PowerSpan II™ Device Errata and Design Notes

80A1010_ER001_13

November 4, 2009

Figure 1: Logic Required to Delay Deasserting PO_RST_ to PowerSpan II

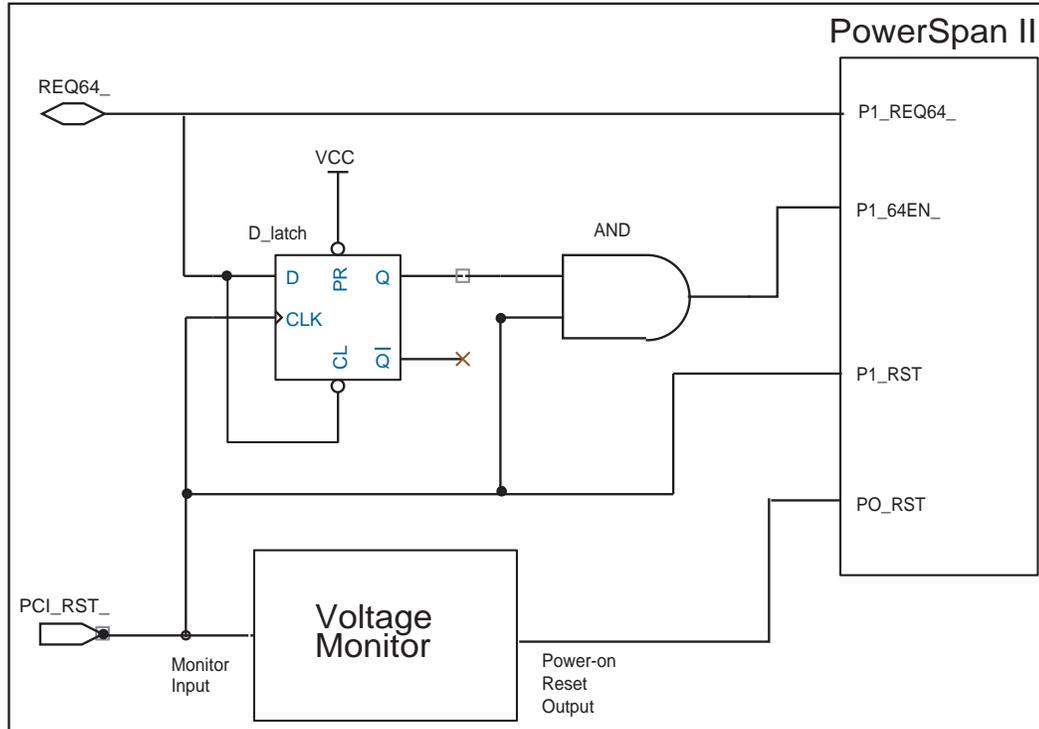
A customer used PowerSpan II in a PCI adapter card application. In this particular application, PO_RST_ was generated by a local voltage monitor device, while P1_CLK was provided by the system controller board through the backplane. Under certain power-up events, P1_CLK only became stable after the local PO_RST_ was deasserted because of different power ramping between the adapter card (containing PowerSpan II) and the system controller card. As a result of the application violating the clock and reset timing restrictions, the PowerSpan II PCI interface does not claim any transactions after reset.

The proposed work-around to this situation is to delay deasserting PO_RST_ to PowerSpan II until the host deasserts the PCI_RST_ signal. Since the PCI_CLK is an output from the system controller along with PCI_RST_, the negation of PCI_RST_ implies the PCI_CLK is stable. The local voltage monitor uses PCI_RST_ to make sure that the PCI_CLK is stable before the deassertion of PO_RST_. A possible implementation of this circuit is shown in [Figure 1](#).

By generating PO_RST_ off of PCI_RST_, there is a chance that the PowerSpan II will be unable to latch the state of the REQ64_ signal on deassertion of PCI_RST_. Therefore, an external D-Latch is used to capture the state of REQ64_ to determine the width of the bus (see [Figure 1](#)). The purpose of the asynchronous clear on D-latch is to prevent potential bus contention on the REQ64_ signal which is driven by PowerSpan II on the deassertion of P1_RST_ in a 32-bit system. The P1_64EN_ signal, which is originally used for CompactPCI Hot Swap applications, is used here to tell the PowerSpan II if this is a 32 or 64-bit application. The AND gate is AND-ing the output of D-latch with PCI_RST_ to ensure the P1_64EN_ is low when the D-latch power-up with uncertain output.

If the external glue logic shown in Figure 1 is implemented by a CPLD, make sure the CPLD output and Flip-flop state are not affected by any reset.

This work-around only applies to designs where PowerSpan II is in a PCI adapter card and is configured for a non-Hot Swap environment. Normally in this scenario, the PCI bus width is indicated by P1_REQ64_ signal (P1_64EN_ is pulled high). For designs where PowerSpan II is in a PCI host card or it is configured for a Hot Swap environment, the circuit shown in Figure 1 must not be used.
